Subject: Lake Tahoe Total Maximum Daily Load for Fine Sediment Particles, Nitrogen and Phosphorus

# Final Lake Tahoe Total Maximum Daily Load

## 18 Appendix B – Responses to Peer Reviews

Figure 2-1. Location of the Lake Tahoe basin (USACE 2003).

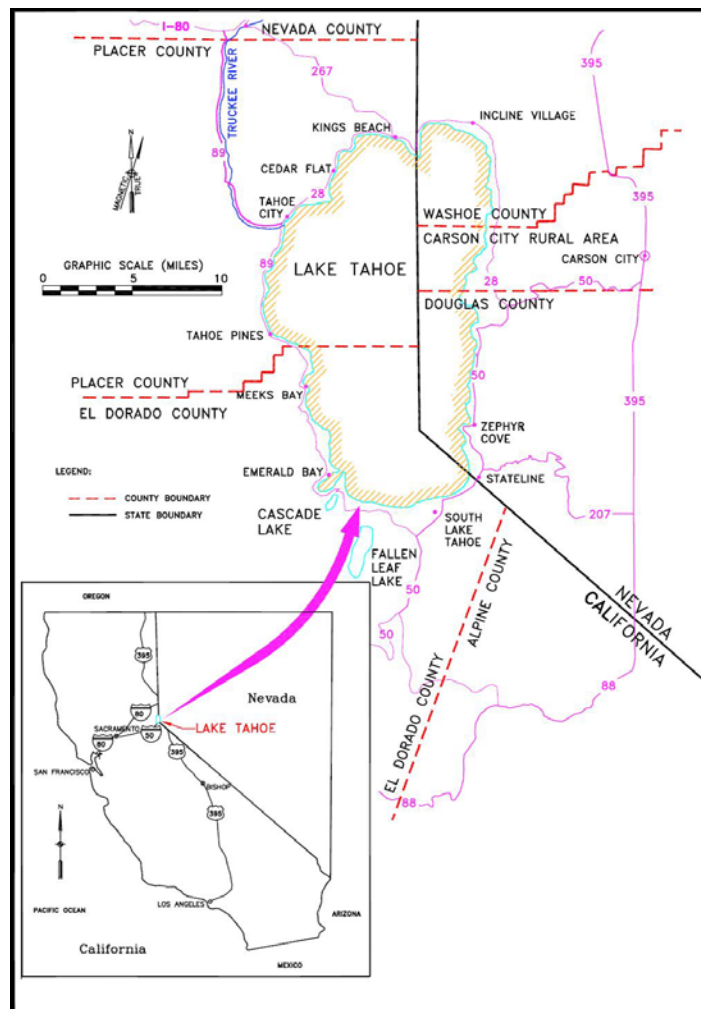
Page	¶/Line	Comment
ES-2	4fb	It would be clearer if the values were given as percentages of the required reduction (e.g., $24.5 \times 100 / 32 = 76.5\%$ of the reduction should come from urban uplands.)
2-1		The map (Figure 2-1) is not very helpful. It is unclear where the line between CA and NV is. It is not clear that the unnamed area on the NW end of the lake is a part of

11-7	16fb	County is identified as Ormsby on Figure 2-1.
	14	Appears to be some missing text at end of line.
11-10		Most of the example load reductions are vague and not very helpful.
12-8	¶ 2	What is this evidence? Merely citing a couple of references is not adequate here. The text should indicate the magnitude of the changes.
	Last ¶	It would be useful to have some measure of variability for the deep mixing phenomenon. (4 ±X years). I suspect the record is long enough to provide a reasonable estimate of the variability in the frequency of deep mixing.
13-4	¶ 1	This paragraph strikes me as indicating that a huge and unseemly amount of bureaucracy is associated with the management of Lake Tahoe.
	¶ 2	It would be useful to say something about the way stormwater samples will be collected. Presumably (hopefully) they will represent event-integrated samples rather than grab samples. Note that “un-ionized” (line 4) should be hyphenated to avoid confusion with the word unionized.

**PB-21:** The location map, Figure 2-1 in the Final Report has been replaced with a more accurate figure.

**PB-31:** The Figure 2-1 has been replaced, the text is correct, it is Carson City Rural County.

Figure 3-1. Relationship between in-lake particle number (< 16 μm) and Secchi depth with P-value = 0.001 and R<sup>2</sup> = 0.057 (modified from Swift 2004).

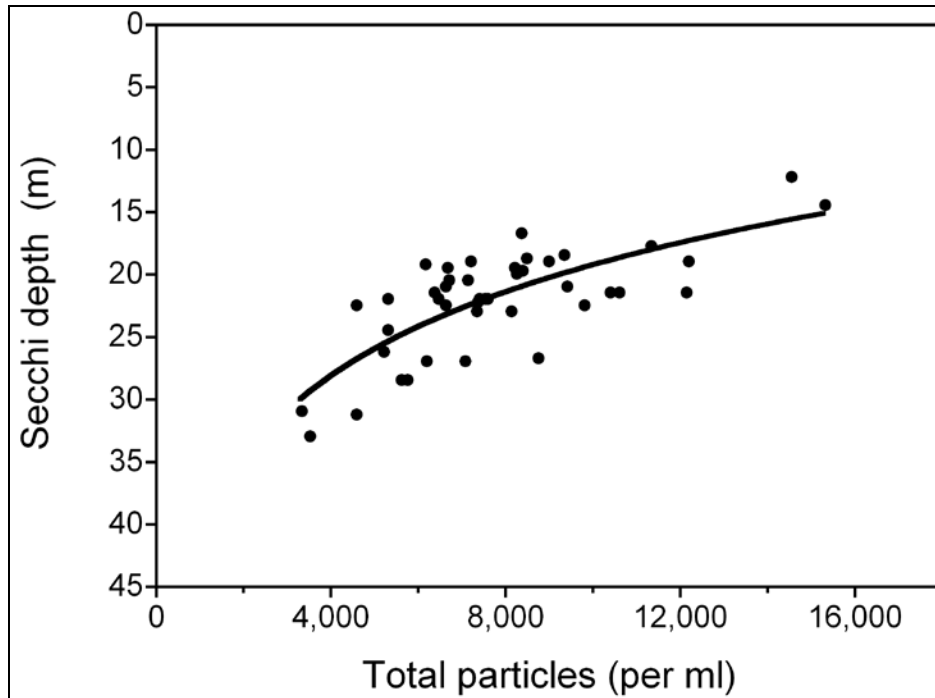
4. The text associated with Figure 3-1 is erroneous, as is the figure itself. The text states that water does not absorb light. This is patently incorrect (see TMDL technical report). Pure water absorbs light and also scatters light. The proportion of light absorbed or scattered depends on wavelength. Particles also both absorb and scatter light, and do so differentially with respect to wavelength. Although the diagram in Figure 3-1 comes from a reputable study (PhD dissertation), it apparently misled the author of the TMDL draft, and should be either corrected or eliminated.

**WL-3:** The text was modified in the Final Report, Section 3.1; and the Technical Report, Section 3.4.1, to correct the discussion. The figure was removed from the Final Report (Figure 3-1) and the Technical Report (Figure 3-8).

Figure 3-2. Influence of particle size on light scattering (modified from Swift et al. 2006).

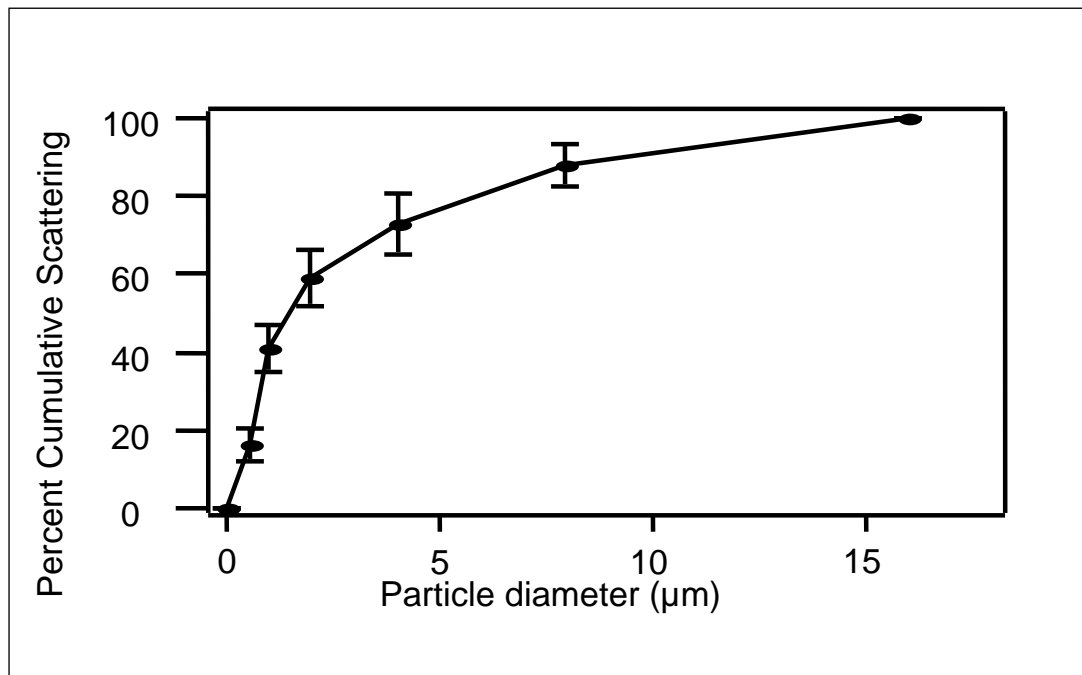
What are the sizes of the particles represented in Figure 3-2?

**WL-5:** The text was modified to clarify this graph (Figure 3-2) in the Final Report in Sections 3.1 and 3.2 and in the Technical Report for Figure 3-8 in Section 3.4.1.

**JM-21:** The size of particles represented in Figure 3-2 of the Final Report (and Figure 3-8 of the Technical Report) were particles <16 µm in diameter. This information was added to the appropriate figure captions.

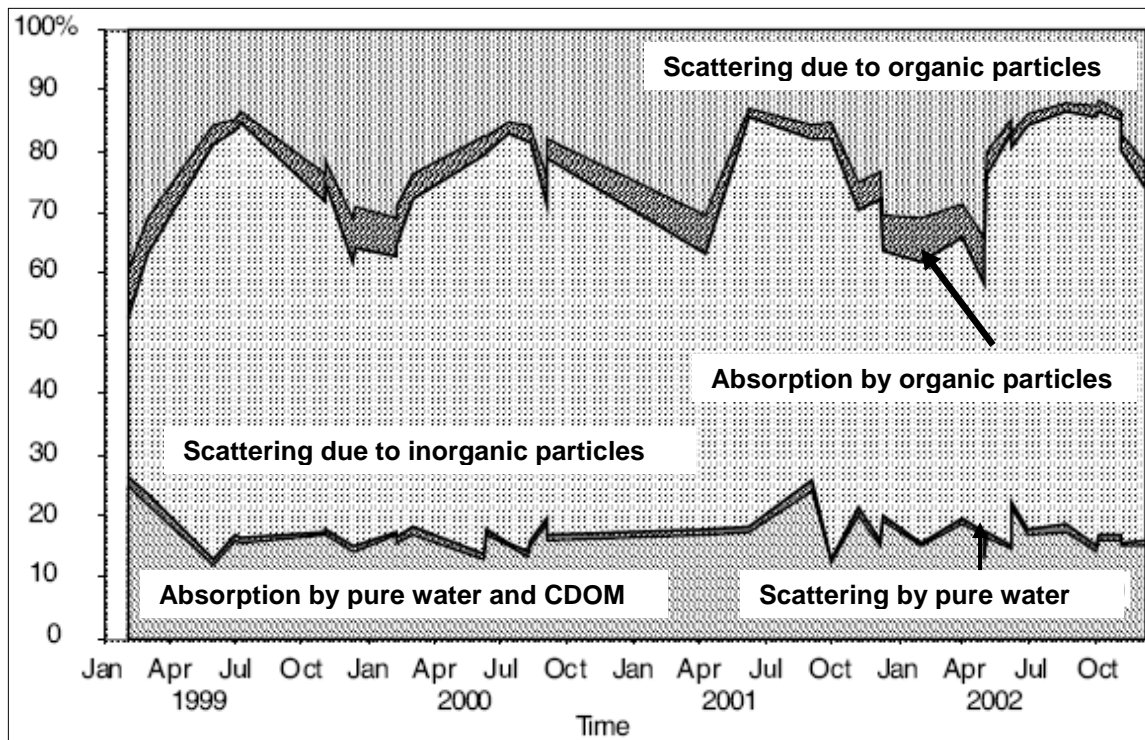
6. Figure 3-3 is difficult to interpret. What is the assumed abundance or mass per unit volume of particles upon which this graph is based? The graph is meaningless without a more complete explanation of the underlying assumptions or of the observations that are portrayed here.

Figure 8-1. Conceptual Lake Clarity Model.

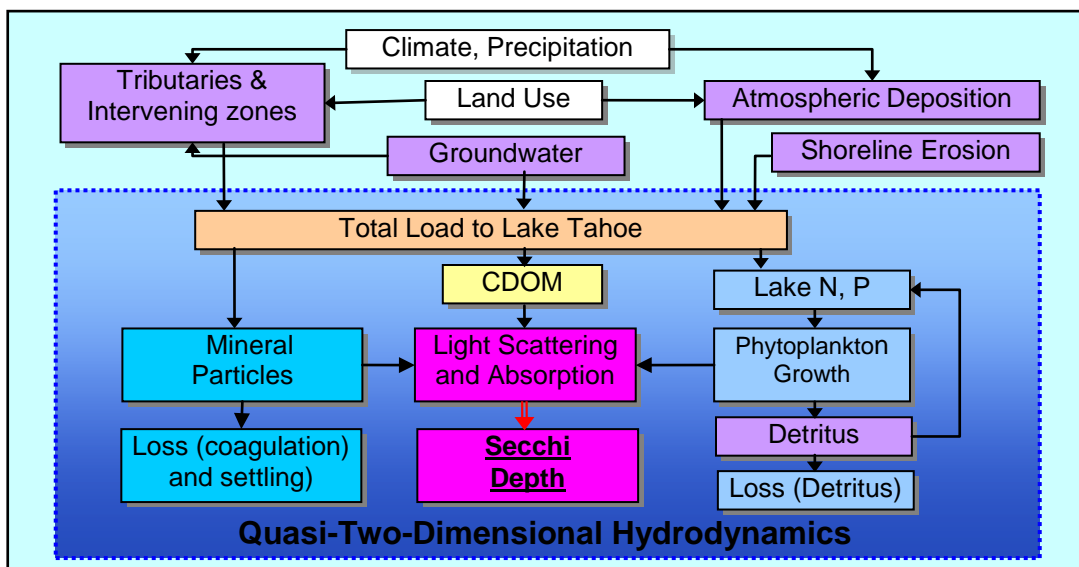
14. In Figure 8-1, the output of the upper part of the flow diagram is shown as total pollutant load. Actually, this load is more correctly referred to as total load. Only a portion of this total is traceable to pollution. We cannot count every ounce of phosphorus, nitrogen, or suspended solids as pollution. Also, in the same diagram, there is a reference to CDOM, which comes in from the watershed mostly. It is good to have this component in the model, but the means of estimating it is not given in the text, nor is any information given on the treatment of CDOM in the model.

**WL-12:** Not all nutrient and fine sediment loading to Lake Tahoe (and to other waterbodies) is a pollutant. The word ‘pollutant’ was removed from Figure 8-1 in the Final Report and Figure 6-1 in the Technical Report. The term ‘pollutant’ is used in the TMDL to include both the nutrient and sediment material because the TMDL allows for reduction of these materials regardless of its ultimate source (i.e. surface runoff can include both anthropogenic and natural sources) and treatment/control applies to the combined load. The CDOM (colored dissolved organic matter) term in the conceptual model (Figure 8-1 Final Report) is supported by laboratory experiments using water from Lake Tahoe. The value used in the model for absorption due to CDOM is given in Table 6-4 in the Technical Report along with a reference.

Figure 8-2. Measured and modeled Secchi depths for 2000-2020. The close agreement during the period between 2000-2005 between field data and modeled output highlight utility of the Lake Clarity Model (Sahoo et al. 2009).

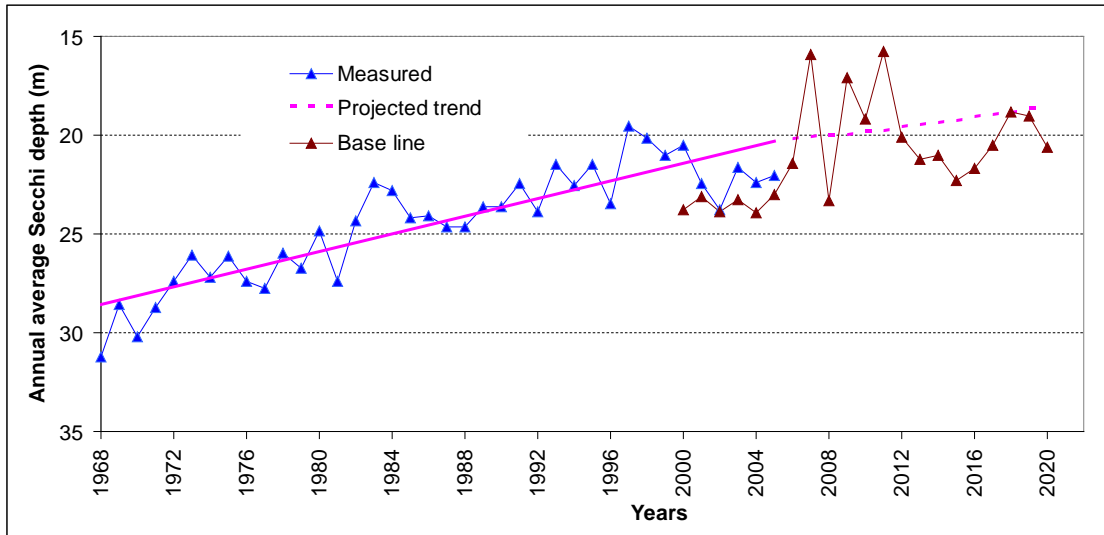
16. Figure 8.2 also poses some problems. Years 2000-2005 are reported to show good agreement, but there are some reasons to question this conclusion, as mentioned above. More troubling is the very wide variation of predicted secchi depths after 2005. The range of variation seen here for predictions is not found anywhere in the previous record of observed secchi depths. Certainly secchi depth observations must

**Figure 13-1. Sampling locations for LTIMP Stream and Lake (TERC) sites (Tetra Tech unpublished). The Index Station is the TERC Monitoring Station that is near the west shore, it is located 2km from the shore and is positioned over deep water (greater than 100 meters deep).**

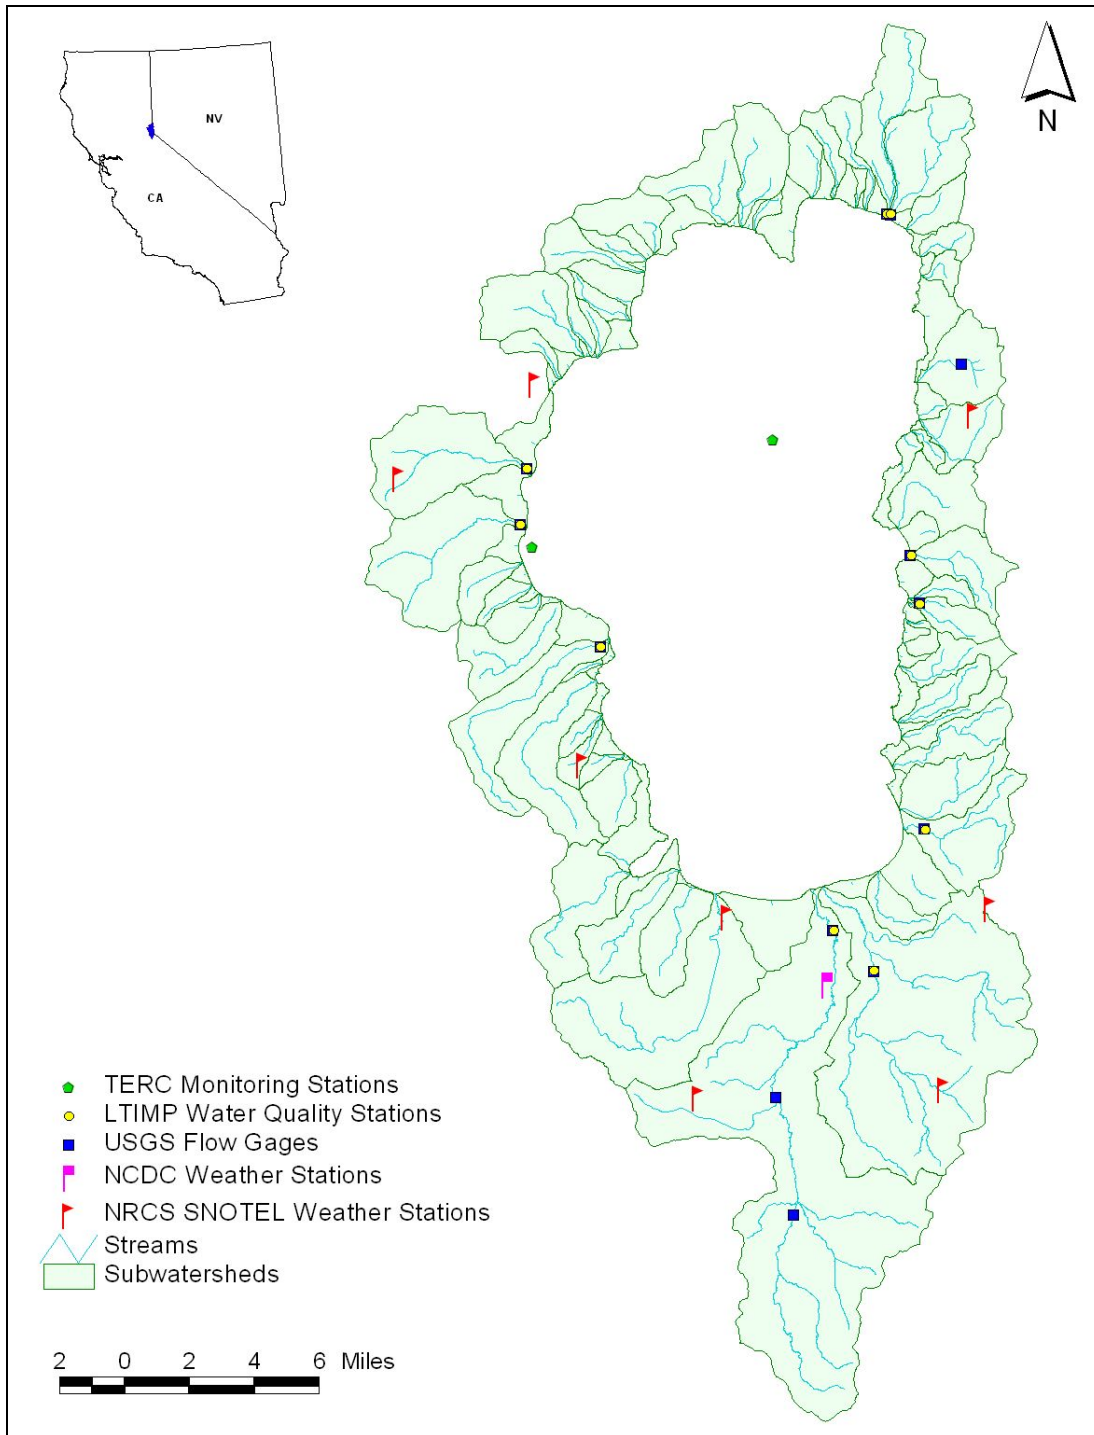
13-7	Last ¶	The text should say how far from shore the index station is. The map in Figure 13-1 shows the station as very close to the shore. Text elsewhere indicates the station is 2 km from shore. The figure may need to be corrected, and it would be useful to label each TERC station on the map.
14-2	1	It is not clear exactly what the \$10 million figure refers to.
14-3	¶ 1	It would be helpful if the text would provide some measure of the uncertainty remaining in the key models and the magnitude by which the uncertainty was decreased as a result of developing the site-specific models.
14-4	8fb	I think the authors mean “First, <i>conservative</i> assumptions were made...” It would help if this paragraph would indicate that examples of the conservative nature of the
